Accessibility Report

Name of business/organisation	Lower Peover Primary School
Address:	The Cobbles Lower Peover Knutsford Cheshire WA16 9PZ
Date of site visit:	Monday 4 November 2019

3.5.5 Internal signage

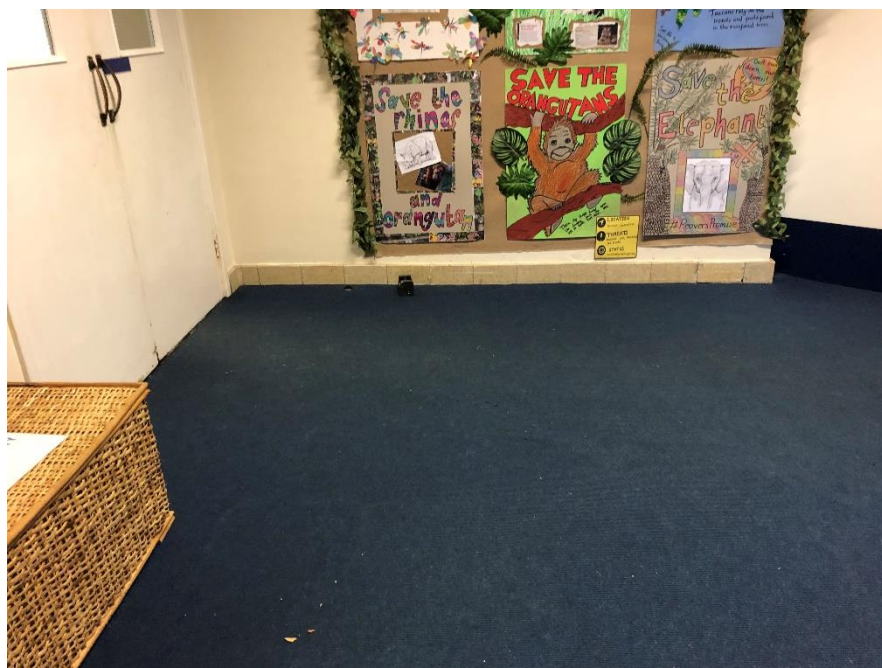
The inner door from the lobby takes visitors directly into a corridor with several doors leading to different spaces, including the accessible toilet, staff office, resource room, main hall and head teachers' office. The different rooms and spaces leading from the corridor were not clearly identified by signage. Therefore it would be difficult for disabled visitors (and others) to find the room they required.

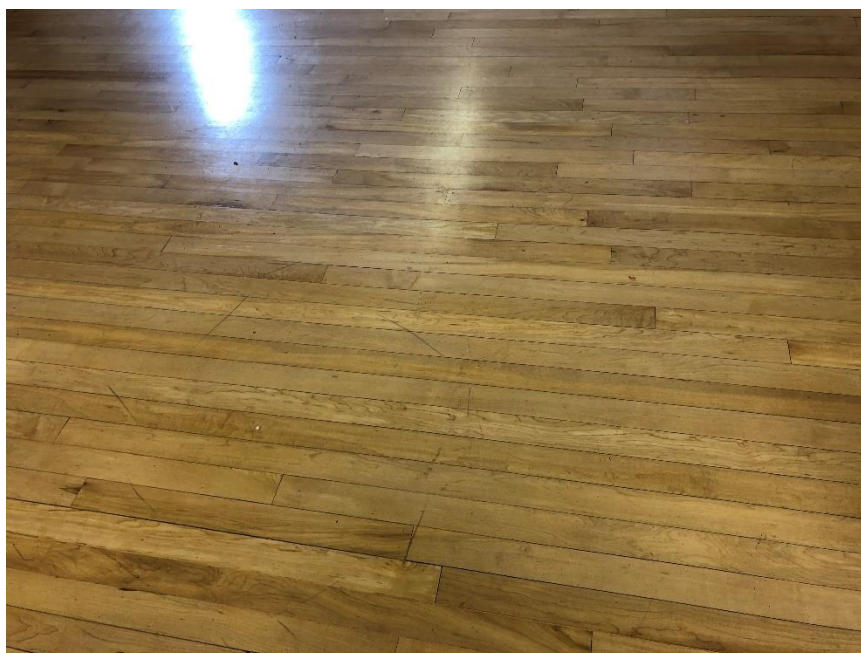
In the corner of the hall there is a shelf with a laptop portal (and two further fixed white boxes above) which projects into the space. Items such as projecting shelves, particularly if they have sharp edges, can cause injury. There is no clear visual contrast against the background to guide people who are blind or partially sighted around.

If projections into the space are unavoidable, provide a guard rail or other hazard protection that contrasts visually against the background to guide people who are blind or partially sighted around these types of projection –
